**ADDENDUM # 1**

<b>Project</b>	TA Blakelock High School Renovations	<b>Project No.</b>	2215-C
<b>Location</b>	1160 Rebecca Street, Oakville, ON	<b>Date of Issue</b>	2025 04 24
<b>Owner</b>	Halton District School Board	<b>File</b>	2215/7.1.3

This Addendum forms part of the Contract Documents and amends the original Drawings and Specifications, dated 2025 04 17, and all preceding Addenda, as noted below.

14 FOUNDATION SECTION DETAIL AT ELEVATOR 2  
A106 1:10

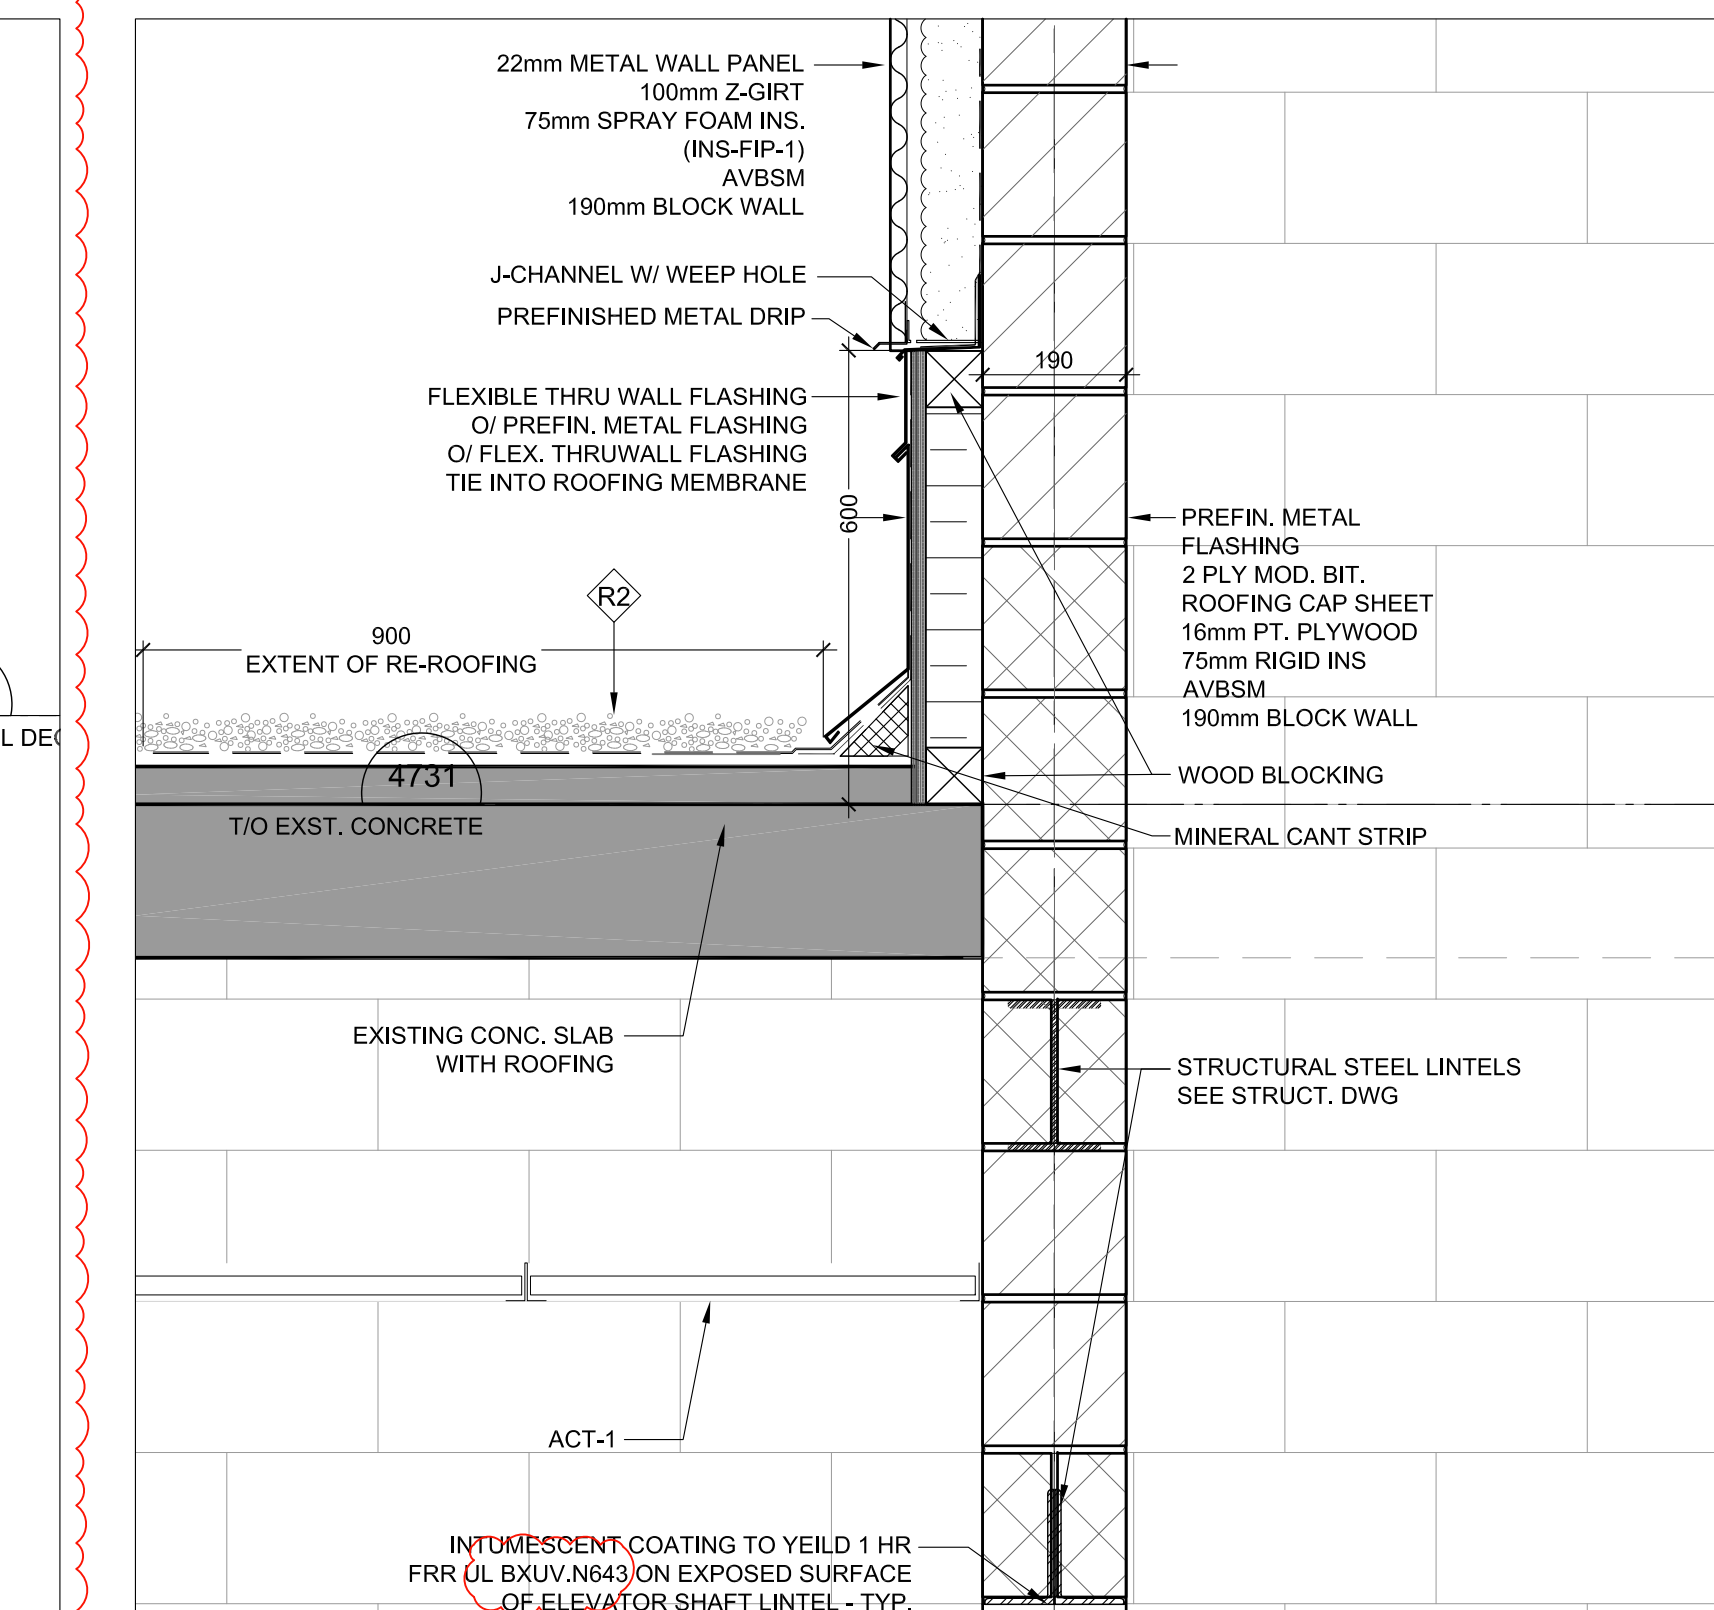
- .1 Replace Drawing with the attached Revision No. 2.
- .2 Drawing reissued to revise fire protection notes and added details 14-18.

3 PARTIAL LEVEL 1 ELEVATOR 02 - DEMOLITION HVAC PLAN  
M101 1:50

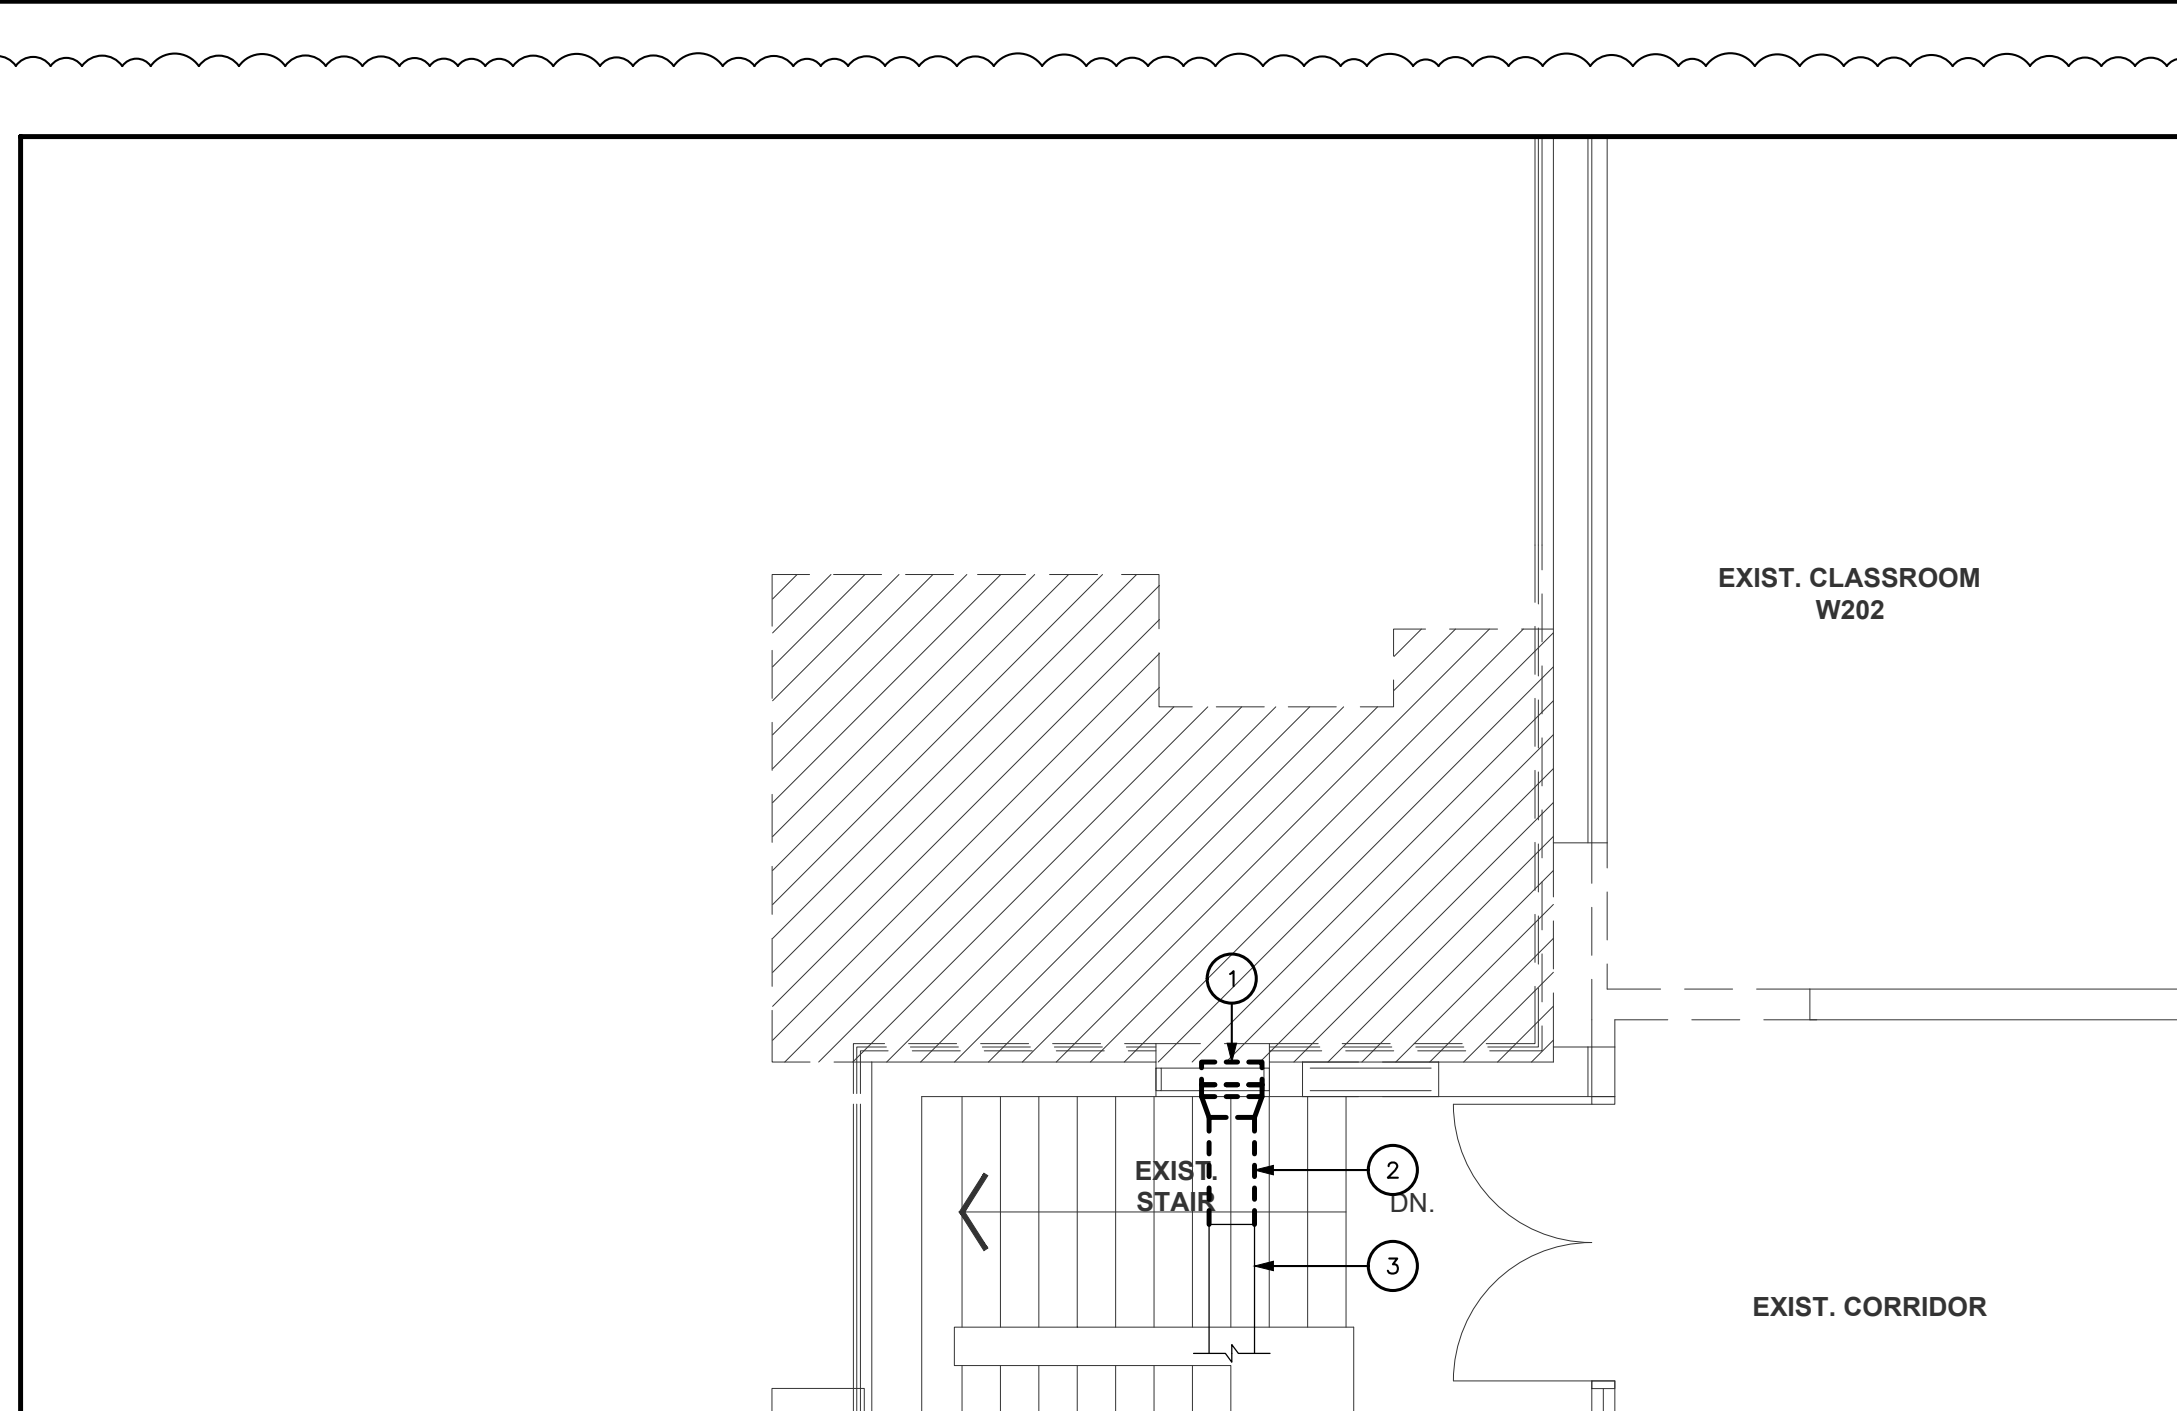
- .2 **Refer to Partial Level 1 Elevator 02 – Demolition HVAC Plan:**
    - .1 **REVISE** Existing ductwork layout as indicated on included drawings.
  - .3 **Refer to Partial Level 2 Elevator 02 – Demolition HVAC Plan:**
